Model: Model SY-P1	Date: 07-Jan-08	No.: RG186001a
--------------------	-----------------	----------------

Subject: Firmware Release Note: Engine Firmware (Package)		Prepared by: Yuji Mimura	
From: 1st Tech. Support Sec. Service Support Dept.			
Classification:	<input type="checkbox"/> Troubleshooting <input type="checkbox"/> Mechanical <input type="checkbox"/> Paper path <input checked="" type="checkbox"/> Other ()	<input type="checkbox"/> Part information <input type="checkbox"/> Electrical <input type="checkbox"/> Transmit/receive	<input type="checkbox"/> Action required <input type="checkbox"/> Service manual revision <input type="checkbox"/> Retrofit information

Model: SY-P1		Date: 30-Apr-10	No.: RG186005
Subject: Replacement of bushing for pressure roller		Prepared by: K. Hamada	
From: 1st Overseas Tech Support Sec., 1st PQM Dept.			
Classification:	<input checked="" type="checkbox"/> Troubleshooting <input type="checkbox"/> Mechanical <input type="checkbox"/> Paper path <input type="checkbox"/> Product Safety	<input type="checkbox"/> Part information <input type="checkbox"/> Electrical <input type="checkbox"/> Transmit/receive <input type="checkbox"/> Other ()	<input checke

G1861306: (The illustration below is on Page 6 in the parts catalog.)

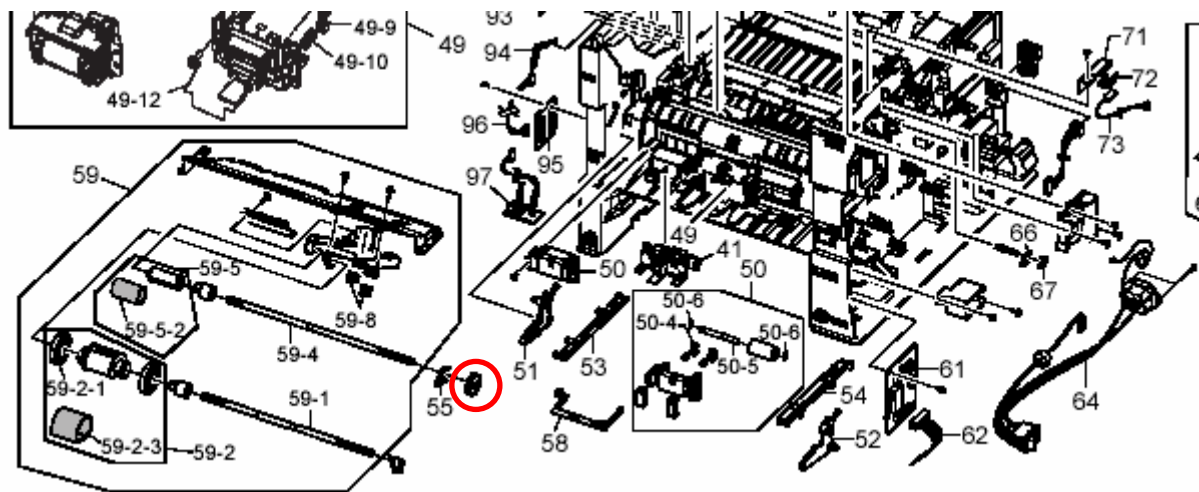
Change: These parts in the table were added.

Reason: To meet requests received from the field.

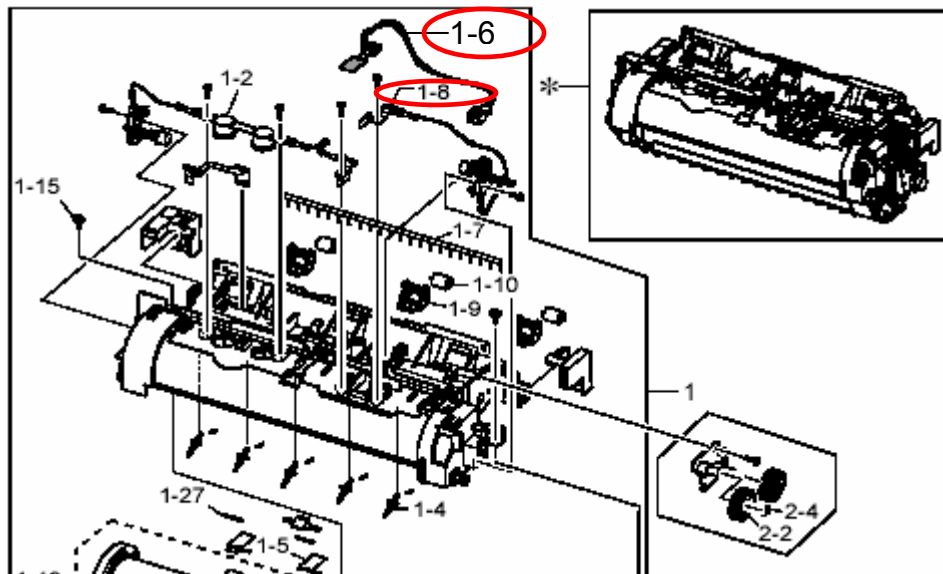
Change: These parts in the table were added.

Reason: To meet requests received from the field.

SYMPTOM

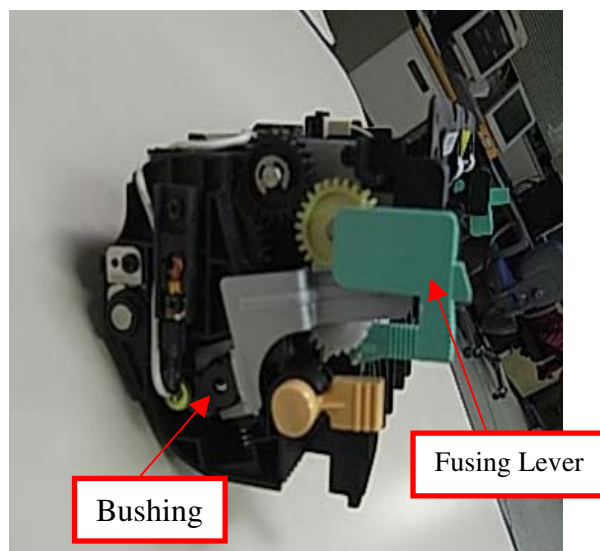
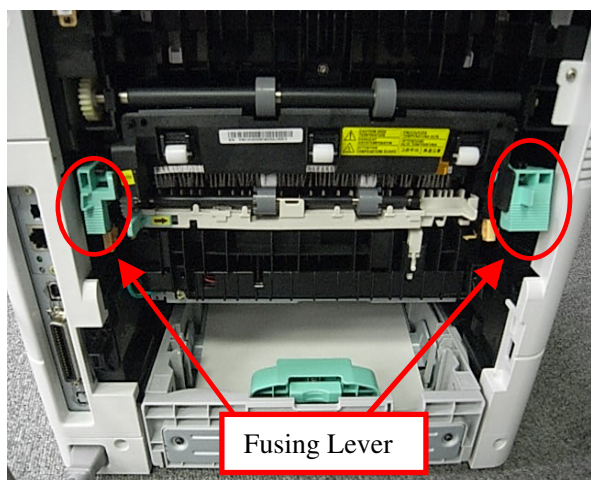
Noise is generated after jammed paper is removed from the fusing unit.

The vendor that produces the pressure roller bushing used the wrong material on the production line. As a result, the bushing breaks when the fusing lever is pushed upward to remove the jammed paper.

If this symptom is reported on the affected units (see below), replace the bushing with the following part (replacement procedure below):

P/N G1869900 Bushing: Pressure roller

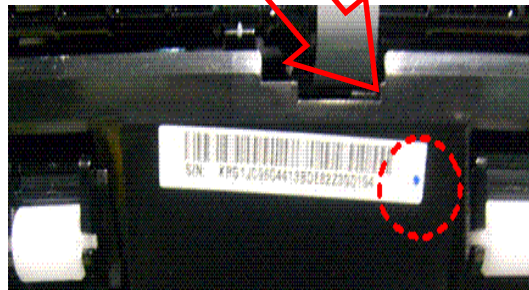
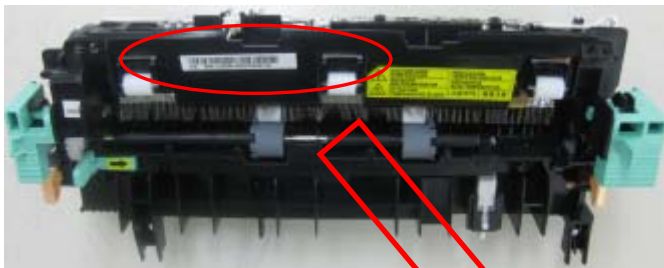
Important: Bushings have already been replaced on fusing units that are marked with a blue dot (see the photo). You DO NOT need to replace these units for this symptom.

(1)

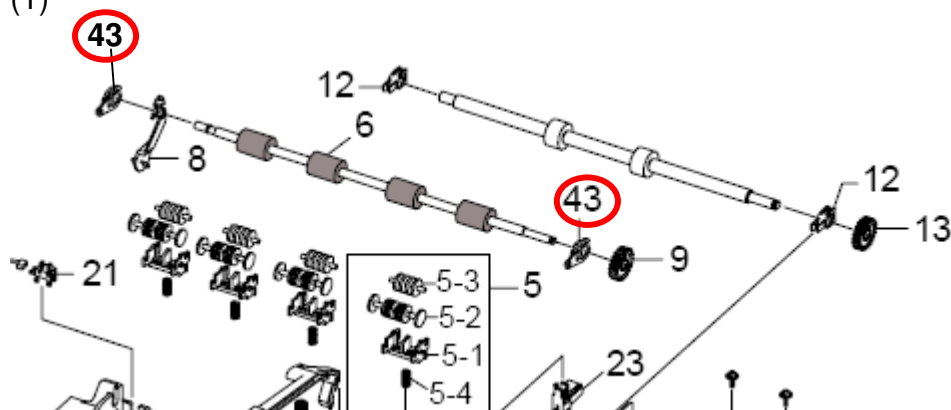
Change: This part in the table was added.

Reason: To meet requests received from the field.

(2)

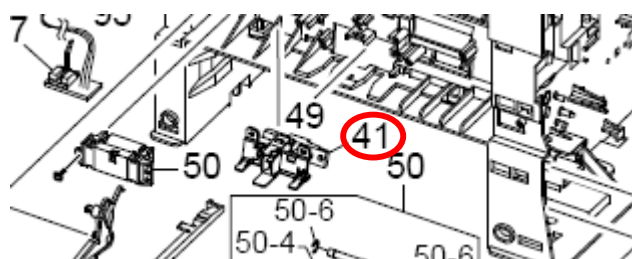
(2) Please correct your parts catalog as follows.

Wrong part number	Correct part number	Description	Q'ty	Int	Page	Index	Note
G1861141	G1861385	RZL:ELAUNITCHECK:JC96-04120A			9	41
